# UNITED STATES PATENT AND TRADEMARK OFFICE

APPLICATION NO.	FILING DATE	FIRST NAMED INVENTOR	ATTORNEY DOCKET NO.	CONFIRMATION NO.
10/799,340	03/12/2004	Doug Wroblewski	0644-032407	6222
28289 7590 12/10/2008 THE WEBB LAW FIRM, P.C. 700 KOPPERS BUILDING 436 SEVENTH AVENUE PITTSBURGH, PA 15219				
EXAMINER				
KENNY, DANIEL J				
ART UNIT		PAPER NUMBER		
3633				
MAIL DATE		DELIVERY MODE		
12/10/2008		PAPER

### Office Action Summary

**DETAILED ACTION**

Annotated Fig. 1 (U.S. Pat. 6,269,495)

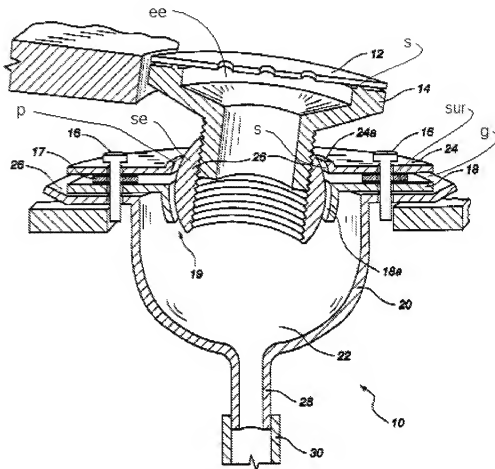
Sondrup discloses a drain comprising:

**Claim 8** - a drain body (18, 20) defining a drain cavity (22);

a frame (14 and se) having a securable end (se) received by said drain body and an exposed end (ee), said frame being rotatable relative to said drain body for adjusting the position of said frame exposed end;

a clamp (16, 24) for fixing said securable end of said frame to said drain body;  
and

a grate (12) received by said exposed end of said frame, wherein said drain body comprises a ledge (18a) having a sloped surface, said frame securable end slidably engaging said surface of said sloped surface of said ledge when said frame is rotated relative to said drain body;

the clamp comprises a clamp body having a protrusion (p) for clamping said frame securable end to said drain body;

wherein said clamp further comprises a fastener (16) extending (in a radial direction) beyond said frame securable end and said clamp body and being threaded into said drain body (col. 3, lines 23 and 24).

**Claim 9** - a drain body (18, 20) defining a drain cavity (22);

a frame (14 and se) having a securable end (se) received by said drain body and an exposed end (ee), said frame being rotatable relative to said drain body for adjusting the position of said frame exposed end;

a clamp (16, 24) for fixing said securable end of said frame to said drain body;  
and

a grate (12) received by said exposed end of said frame, wherein said drain body comprises a ledge (18a) having a sloped surface, said frame securable end slidably engaging said surface of said sloped surface of said ledge when said frame is rotated relative to said drain body;

the clamp comprises a clamp body having a protrusion (p) for clamping said frame securable end to said drain body;

wherein said drain body comprises a fastener receiving member (18a) extending into said drain cavity whereby said clamp body protrusion is configured to clamp said frame securable end to said fastener receiving member.

clamp body having a protrusion for clamping said frame securable end to said drain body, and wherein said clamp body comprises a sloped drain body engaging surface (s) to provide a gap between a portion of said drain body engaging surface and said drain body.

**Claim 6** – The frame exposed end comprises a seat (s), said grate being fixed to said seat.
